**Monks Orchard
Residents 'Association
Planning**

Reference: 24/04217/FUL
Application Received Thu 12 Dec 2024
Application Validated Tue 11 Feb 2025
Address: 23 Woodland Way Croydon CR0 7UB
Proposal: Demolition of existing dwelling and erection of 2 x 4-bed dwellings with associated parking, cycle and refuse storage.
Status: Awaiting decision
Case Officer: Tracey Williams
Consultation Date: Fri 14 Mar 2025
Determination Deadline Tue 08 Apr 2025

Please accept this **representation** from the **Monks Orchard Resident's Association** to the proposed Application **Ref: 24/04217/FUL** for Demolition of the existing dwelling and the erection of 2 x 4-bed dwellings with associated parking, cycle and refuse storage at **23 Woodland Way Croydon CR0 7UB**.

Google Earth Image showing approx. Site Area of significant overgrowth vegetation and the public footpath access from woodland Way to Firsby Ave.

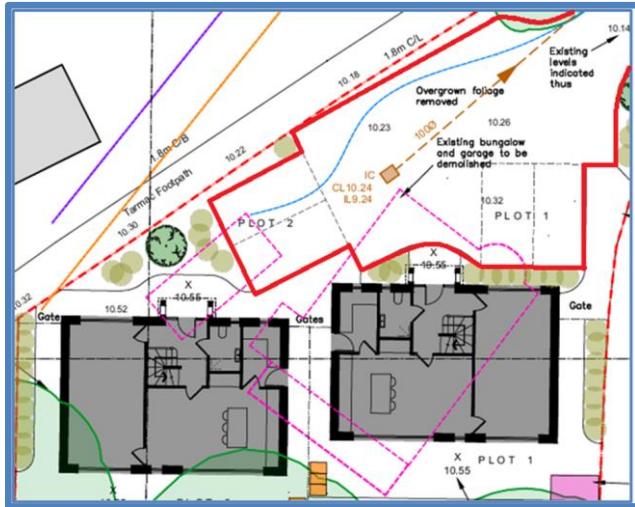
The **Site Area** is overgrown with natural vegetation, and it is understood the bungalow has been severely neglected and is rather dilapidated.

Extract from block diagram illustrating access to the site

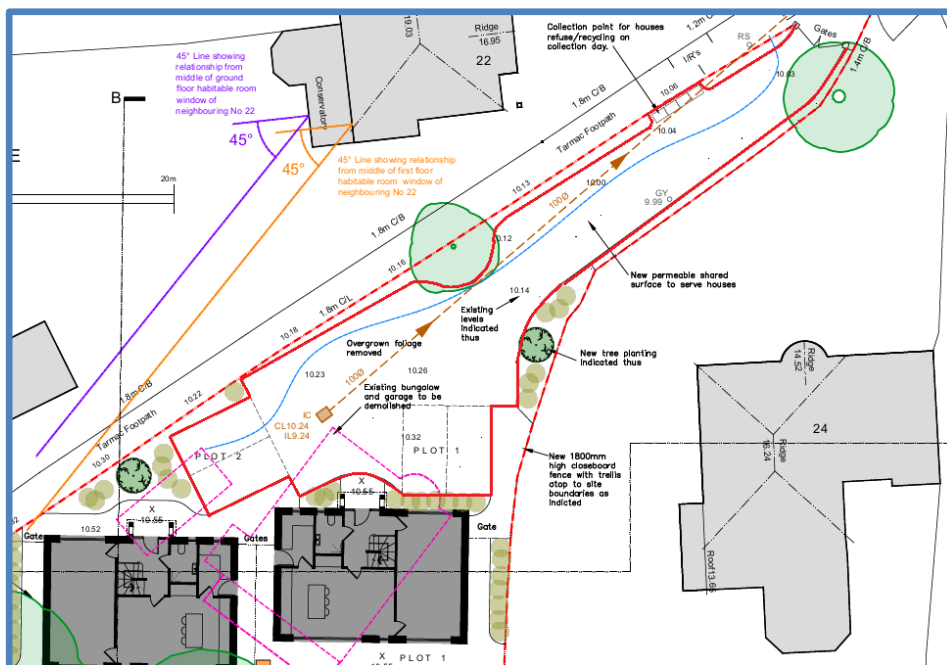
We have not been able to assess with accuracy, whether the entrance to the site by a family sized vehicle would be possible between the entrance to **24 Woodland Way** and the entrance to the **Public Footpath to Firsby Avenue**, restricted by the **Fire hydrant Notice** located at the side of the **Access**.

Would it be necessary to move the **hydrant notice**?

Scaling off the provided block diagram indicates a **width between proposed new Gateposts of ≈2.5m, restricted by the Fire hydrant Notice**. The type of car greatly affects the size or dimensions of the car park. An ordinary SUV has dimensions of **4.9 meters to 5.8 meters in length**, and a **width of 1.8m to 2.1m** which would leave **20cm (0.2m) clearance each side** (rather tight).

It is proposed that **Refuse & Recycling Bins** are located within this boundary including possible **Bulk Waste collection point**, which may also **restrict the passage of vehicles**.

It is NOT possible for a **Fire Appliance** to enter the Drive with **Gateposts** of **≈2.5m** width which is **restricted by the Fire hydrant Notice** (See Photograph above).
